DELEGATED DECISIONS BY CABINET MEMBER FOR TRANSPORT MANAGEMENT

OXFORD: ROSE HILL – PROPOSED TRAFFIC CALMING MEASURES AT SERVICE ROAD JUNCTIONS

Report by Director of Environment and Highways

RAISED SIDE ROAD ENTRY TREATMENTS

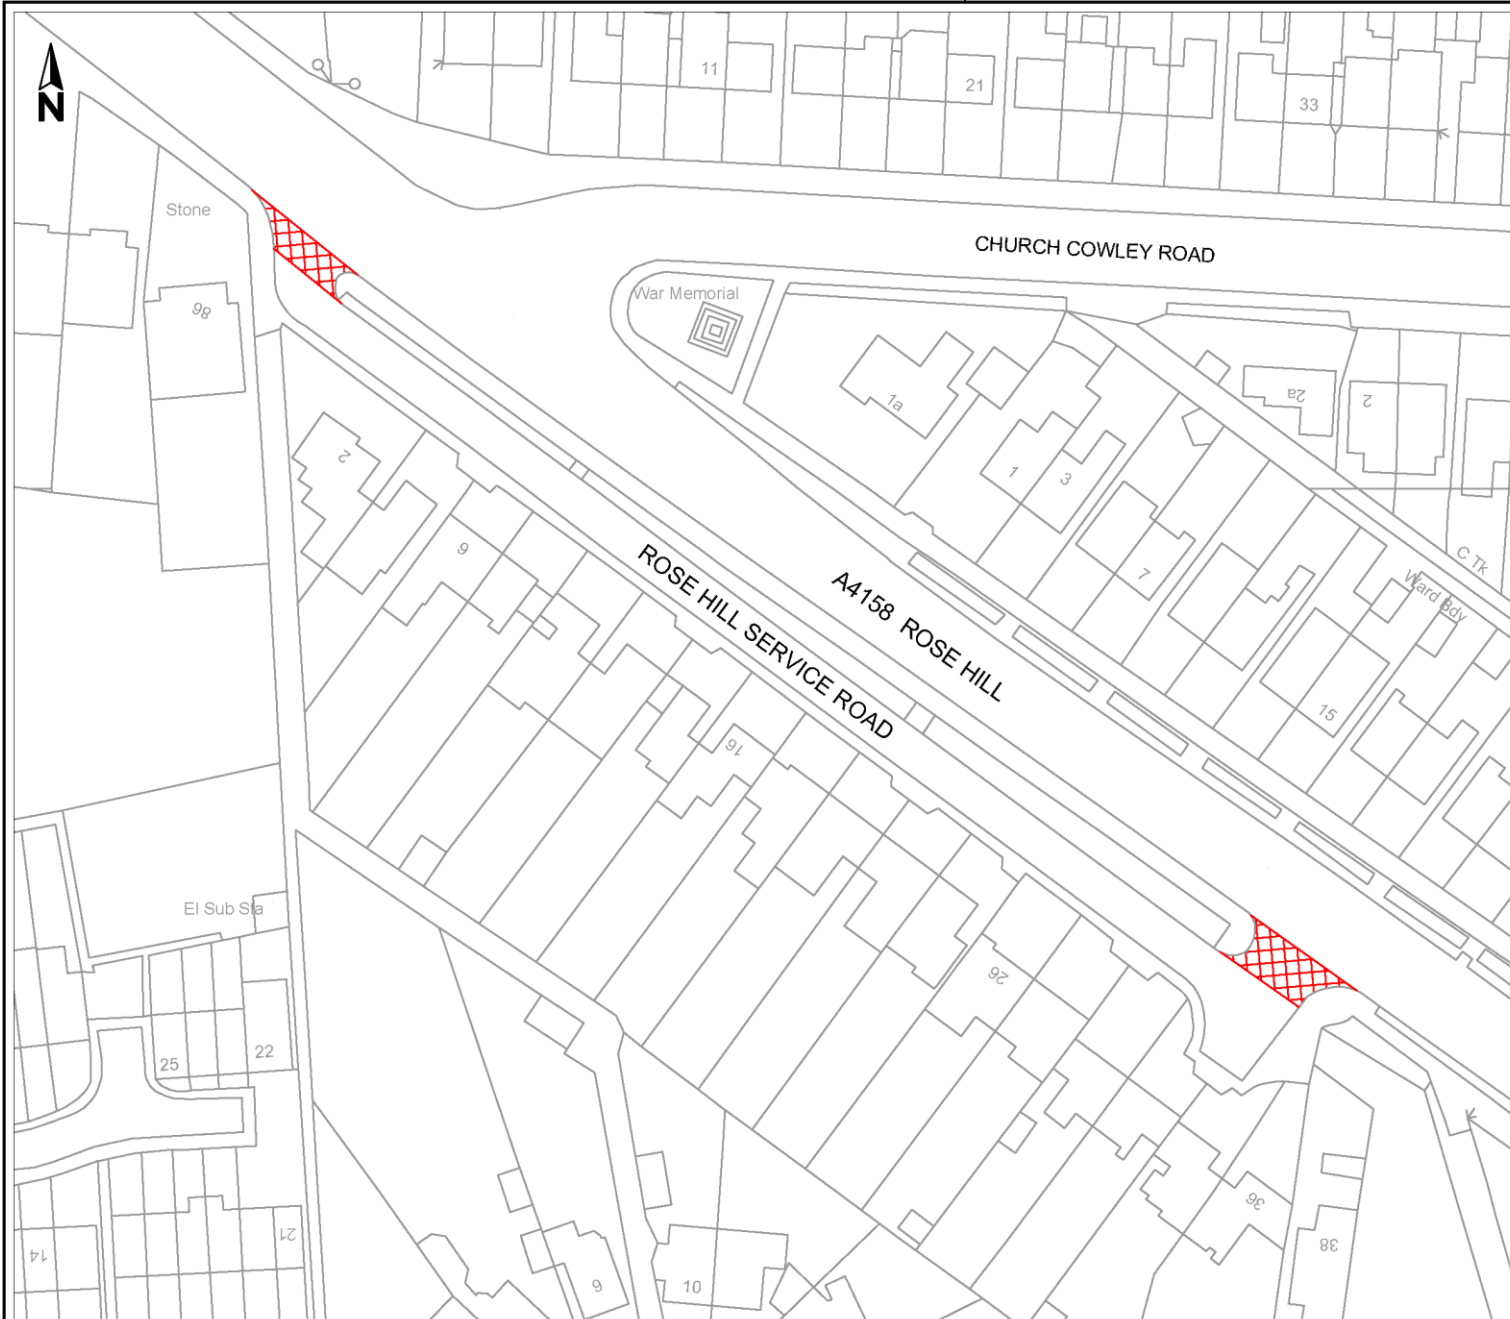
RESPONDENT	COMMENTS
(e1) Traffic Management Officer, (Thames Valley Police)	No objection
(e2) Local County Cllr, (Rose Hill & Littlemore division)	<p>Concerns – The junction of church Cowley road and rose hill road requires better pedestrian access, this could be in the form of a pelican crossing in both directions.</p> <p>I am concerned with the current proposal for a raised surface to the service road. Ascending from rose hill the cycle lane is positioned in the road, the service road is a sharp 90 degree bend at the apex of hill, meaning cycles tend to travel at speed. As the raised platform is not yet at the foot of the hill cyclist in poor weather conditions will find it difficult to make the sharp left turn over a raised surface. For pedestrian access see the value but duets higher cycle speeds in a braking zone I believe cyclist could in fact be putting cyclist at risk. If we follow the principle of braking in a straight line.</p>

(e3) Local County Cllr, (Cowley division)	<p>Concerns – I would like to add after the speeding camera from service road to the traffic light the footpath should be replaced with segregated cycle line with metal barrier to protect the cyclists.</p> <p>The pedestrians can use the footpath front of the houses at service roads.</p> <p>The opposite side of the road have separate footpath to use. Happy to meet and explain at the spot.</p> <p>On a same stretch at the traffic lights, we need a right turn filter for vehicles to turn from Rosehill road to Church Cowley road.</p> <p>Currently drivers are jumping the red lights to turn right which accident is waiting to happen.</p>

<p>(e4) Local group/organisation, (Cyclox)</p>	<p>Object – We object strongly to this proposal as it does not address the fundamental problem of safety at this junction. We objected to the redesign of the Church Cowley Road Rose Hill junction when you proposed it in January 2024. As a reminder here is our response to that design outlining our objection. This is what we wrote then about the Rose Hill service road:</p> <p>“Cyclox continues to have grave concerns about the redesign of the junction of Church Cowley Road with Rose Hill. The four recent collisions involving cycle riders at the southern entry to the service road demonstrate that there is a problem with the road layout after the Quickways design. However we do not believe that the redesign that you shared with us will remove the problem of left-hooks on the service road entry, as drivers, having learnt that that option is open to them, will continue to use the service road to bypass the junction. So the risk to cycle riders will continue. We think that the only effective way to remove any risk to people on bikes at the service road entrance is to have modal filtering, or at least making the service road one-way southwards, with contraflow cycling. It looks like there is plenty of turning room at the southern end - at worst a bin lorry or truck might have to three-point turn. Re-entry onto the carriageway for those going north bound could be protected by wands.”</p> <p>While creating a side road entry treatment for the Rose Hill service road is a nice-to-have, it does not address the fundamental problem which is the use of the service road as a bypass of the traffic lights which is, as we predicted, a continued problem. We wish to see the service road made one-way southbound but of course with contraflow cycling (something we wish to see on all one way streets in Oxford). This will remove the risk of hitting cycle riders as car drivers make the left turn.</p> <p>Rather than spend fairly large amounts of money on a side road entry treatment here, we suggest that a much better use of the fund (which is after all a fund to improve road safety, would be to make the service road one-way south bound.</p> <p>We continue to press for a redesign of this whole junction as pedestrians find it very difficult to cross.</p>

<p>(e5) Local group/organisation, (Oxfordshire Liveable Streets)</p>	<p>Concerns – Putting side road entry treatments on the Rose Hill service road is useful, but fails to address the core problem with motor traffic using the service road to bypass the traffic signals. The service road should be filtered, or made one-way southbound (with contraflow cycling), to prevent this. That would largely eliminate the hazard (of motor traffic turning across people walking and cycling) instead of just ameliorating it (by slowing down motor traffic turning into or out of the service road).</p>

<p>There are understandable concerns about people being injured by motor traffic turning into and out of the service road, but there are other harms done by allowing motor traffic to bypass the junction, including road danger and speeding on the service road as well as noise. Allowing motor traffic to bypass signals also undermines their use for traffic management, including bus prioritisation. (As a route usable by cars but not buses, the service road is currently operating as a car prioritisation measure.)</p> <p>The other major problem with this junction is that it lacks pedestrian signal crossings and support for cycle right turns. The most obvious solution seems like some kind of CYCLOPs design, with signal crossings on all arms and signal-protected cycle movements.</p> <p>Rather than spend fairly large amounts of money on SRETs here, it would be better to put in place a cheap modal filter or one-way restriction, and set aside funding towards a full redesign of this junction (which would include SRETs).</p> <p>We also urge that, unlike the "Safer Roads" SRETs planned elsewhere on Iffley Rd, any SRETs put in here have the footway coloured/textured so as to be clearly distinct from the carriageway - i.e. not in simple black asphalt.</p>

(e6) Local resident, (Oxford, Westbury Crescent)	<p>Object – I have completed the consultation on the Rose Hill service road treatments and have objected to those as they don't address the problem. The solution needs to stop drivers turning left into the service road above the traffic lights to finally make the cycle lane safe for all those cycling in it.</p> <p>As you will see I have attached an extensive collection of correspondence I had with the local Cllr about the changes planned and then made to the 'Quickway' at the Church Cowley Rd junction. These explain my objections in much more detail. This junction is now a very dangerous one for people cycling or walking, just as it was before the original 'Quickway' was implemented.</p> <p>The new Iffley Rd/Rose Hill 'Quickway' was a complete game changer for cycling when it was put in even for me as a very experienced and generally confident cyclist of some 45 years. It really transformed the experience of cycling into Oxford and back again very positively. I was so relieved by this wonderful piece of infrastructure.</p> <p>I was completely dismayed by the change made to remove the protected cycle lane down hill and reinstate the two traffic lanes downhill. I feel really unsafe going down hill now and have decided from this week with the new school term to avoid it all together and make a longer annoying detour. I also feel completely unsafe coming uphill so that I have decided since last winter to use the pavement instead rather than risk any more close passes in peak times especially when it is dark.</p>

RESPONDENT	COMMENTS
(o1) Local resident, (Oxford, Morrell)	Object – Just make the side road one way southbound, or better stop the traffic with bollards. This proposal is an expensive way not to fix the problem: too many cars using the road.
(o2) Local resident, (Oxford, Rosehill)	Object – There is already a safe pathway and a waste of money. Car users are driving through to jump the lights at fast speeds making the service lane extremely dangerous . It would be better to close off one end of the service road,with bollards placed only for cyclists and pedestrians to travel through.What is really needed is a safe pedestrian crossing, either at the traffic light or further up the hill near the speed camera.
(o3) Local resident, (Oxford, Westbury Cr)	<p>Object – I object to the side road treatments for the service road as they will not solve the problem which they are supposed to address. The problem is that when the traffic backs up the hill from the traffic lights, drivers are often using the service road to cut round the traffic lights and thus endangering people cycling when drivers turn left suddenly in to the service road and across the cycle lane. Before the original Quickway implementation this was often a problem. After the implementation it became worse and several accidents happened. The removal of the protected cycle lane and reinstating of the two vehicle lanes have done nothing to improve the traffic flow at peak times and people cycling continue to be at danger.</p> <p>To stop this the only way is to actually block the left turn with a bollard or planter at the top of the service road. All traffic using the service road will then use the entrance/exit below the lights. Please don't waste money with these surface treatments when they won't deal with the issue.</p> <p>The reinstating of the two downhill traffic lanes and the removal of the protected cycle lane has significantly increased the danger for all people cycling. Not just down hill but also up hill as drivers pass much too close, less than the required 1.5 m from the cycle rider. I now feel so endangered uphill, particularly in the dark that I have stopped using the road and use the pavement instead. And then there is the matter of what people wanting to cross the junction on Rose Hill or Church Cowley road. They have no pedestrian phase and on Rose Hill have to face 5 separate lanes of traffic to get across.</p>

<p>(o4) As part of a group/organisation, (Oxfordshire Cycling Network)</p>	<p>Partially support/concerns – We partially support the proposal for SRETs on the Rose Hill service road because we think this is an expensive and ineffective solution to the main problem of car drivers using the service road to 'rat run' around the traffic lights at the Church Cowley Road junction. When traffic is backed up at the lights, motorists will still use the service road.</p> <p>In addition, the SRETs will make the service road less useful for cyclists, who will be more affected than car drivers by tackling the sharp camber transition of the Dutch kerb at a shallow angle.</p> <p>There are benefits to pedestrians, who would gain a flat, continuous walking surface next to the A4158, although pedestrians may prefer to walk round the service road for quietness and safety.</p> <p>We recommend two alternative solutions:</p> <ul style="list-style-type: none"> a) Filter the service road at the west end, with a modal filter. b) Make the service road one-way from west to east, with cycling contraflow. <p>Both of these would be significantly lower cost and solve the rat-running problem more fully.</p>

<p>(o5) Local resident, (Oxford, Church Cowley Road)</p>	<p>Partially support/concerns – If the problem that needs fixing is impatient drivers using the side-road to shortcut the lights, they're only going to stop when it no longer saves them time. A slight speed-bump and texture change gives the appearance of welcoming pedestrians, but won't have much effect. Turning the northern exit into a right-angle, rather than a 45° slip-road, would at least make them more likely to slow down and look round before pulling out onto the main road again -- this has already been shown to be effective further down the same road, at the Iffley Turn/Cornwallis junction. But the most effective change would be a traffic restriction, such as a modal filter or a one-way system (heading north-to-south).</p> <p>If you're looking to reduce the queue so drivers aren't tempted to use the short-cut, the timings at the lights aren't suited to the current layout of the junction: vehicles heading north and turning east (into Church Cowley Road) have to wait for the lights to change and the line heading south to stop, and then stay blocking the junction for the queue waiting on CCR, until they are able to squeeze past the parked cars that line both sides of the road there. Either remove the parking, or provide a dedicated right-turn phase.</p>

<p>changes here but I'm not convinced these will be enough to dissuade the already more unscrupulous drivers from using the service road as a high speed short cut. I think the best approach would be to make it a one-way street, with traffic only permitted uphill (southbound). That would retain access for all but make it unviable as a cut-through. It's already too narrow for two-way traffic as it is, so it seems sensible to make it officially one-way.</p> <p>I appreciate the efforts to make it easier for pedestrians to cross, though. It's so hard to cross here with a buggy. Nevertheless, with many fast-moving cars coming from all directions, the ease of a raised crossing won't negate the danger posed by the traffic.</p>
(o7) Local resident, (Oxford, Florence Park Road)	<p>Partially support/concerns – Better than nothing, but doesn't fix the rat run problem. Just go and watch the traffic there during rush hour - a constant stream of cars speeding down the hill to skip the lights - an SRET isn't going to stop them. Residents will complain, but this road obviously needs a traffic filter on one end to actually fix the problem. Be brave (and save the SRET money for something more effective).</p> <p>It's a bit of a game to the rat runners - the more stuff you build that is ineffective, the more emboldened they are that they will beat the system, and they will keep rat-running, and will be more emboldened to do it faster, and in other places. They will laugh as they bounce over your dutch kerbs.</p>

(o8) Local resident, (Oxford, Rose Hill)	<p>Partially support/concerns – 1. The problem is the 'shortcut', necessitated by LTN traffic increases. So, LTNs have created the issue. 2. Making the road one-way (no entry from the upper end) would entirely resolve the issue, at much less cost. 3. The junction needs a pedestrian crossing! It is so busy at Church Cowley Rd / Rose Hill / Henley Avenue but there is no crossing. The traffic has drastically increased (see point 1) and many cars jump red lights at every change.</p>
(o9) Local resident, (Oxford, Rose Hill)	<p>Partially support/concerns – I fully support traffic calming measures on this slip road and have been in discussion with local MP and councillors over many years. Since the introduction of LTNs there has been a major increase in traffic at this junction more people turning right into Church Cowley Road to access Cowley Road. This has resulted in people using the slip road as a rat run avoid the lights and queue at the junction.</p> <p>Although it's a 20 mph zone the drivers involved are driving at 50mph plus as there only aim is to beat the light. This means they also cut in at short notice which can mean hitting cyclists on the inside lane which I have personally</p>

(o17) Member of public, (Oxford, Stratfield)	<p>Partially support/concerns – The basic problem is people using the service road to bypass the traffic lights. This doesn't fix that. Please include a modal filter, or make the service road one-way southbound.</p>
(o18) Local resident, (Oxford, Bulan Road)	<p>Partially support/concerns – I sometimes cycle across the junction and find it quite scary</p>
(o19) Local resident, (Oxford, Rose Hill)	<p>Partially support/concerns – I do support the improvements suggested but don't feel they will fully address the issue of cars turning into the road dangerously quickly and speeding down the road to avoid waiting for the lights. This is a problem for anyone walking or cycling down Rose Hill or in the service road. I think this also needs to be addressed at the same time.</p>

22. Speed humps would be effective in reducing speeds and in deterring traffic from using the service road to bypass the signals. It is something that could be

considered in the future if the problem persists; however, streetlighting will be required at each feature and the potential for noise generation is likely to be unpopular with the residents closest to the humps.

23. Creating a one-way street, north to south, would eliminate the turning movement that has caused collisions in the past. The main difficulty is that the northern access, which is at an acute angle to Rose Hill, would not be readily accessible for vehicles from the south. As well as potentially causing traffic delays whilst making the awkward left-turn manoeuvre, these vehicles will be moving across the advisory cycle lane which will increase the risk here to cyclists. It may also be impossible for longer vehicles to make the turn with the traffic island and parked cars present.

24. Installing a modal filter at one end would also eliminate the through traffic in the service road, but is impractical as there would not be a suitable turning area for vehicles, including Refuse Collection Vehicles. A turning head does exist at the southern end of the service road, but a closure here would require all vehicles to enter at the northern end, with the same limitations as per the one-way street.

25. For the reasons given above, it is considered that the SRETs offer the preferred practical and viable means of dissuading vehicles from using the service road to bypass the signals, and to slow down those vehicles that still do make that manoeuvre. If further measures are still considered desirable in the future, these could be investigated, subject to consultation and funding
